County of Loudoun
Office of Transportation Services
MEMORANDUM

SUBJECT: ZMAP 2006-0011, ZCPA 2006-0003—Stone Ridge Commercial
Third Referral

Background

Figure 7
Future Proposed Lane Use and Traffic Control and
Peak Hour Levels of Service

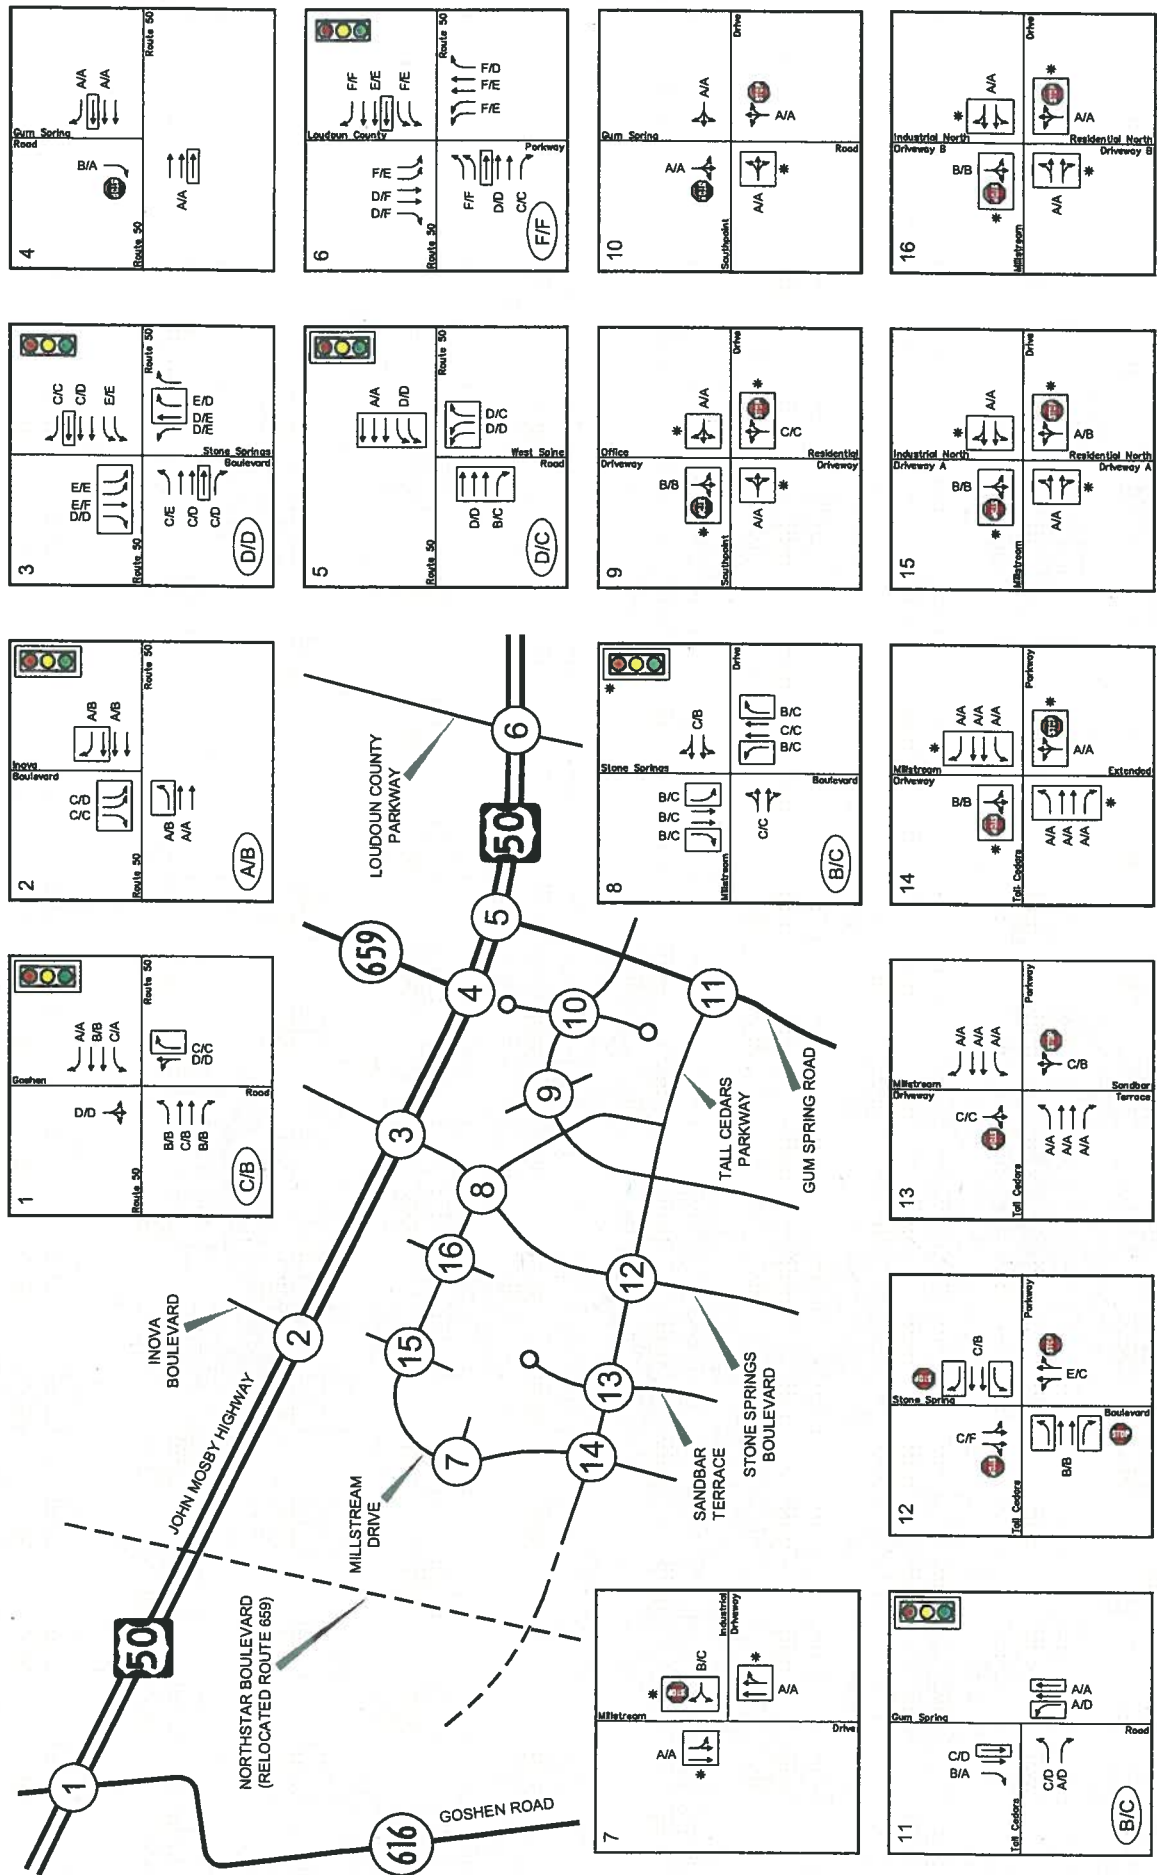
10. Initial Staff Comment (2nd Referral, April 17, 2009): The Applicant should commit to implement/construct the on-site "proffered" and "site" improvements identified in the updated traffic study for the proposed development program (see **Attachment 10** [in the 2nd OTS Referral]). The study indicates that these improvements are necessary to realize the forecasted peak hour intersection LOS conditions presented.

Applicant's Response (June 16, 2009): *The proffers for the proposed development program commit to implementing/constructing both the "proffered" and "site" improvements.*
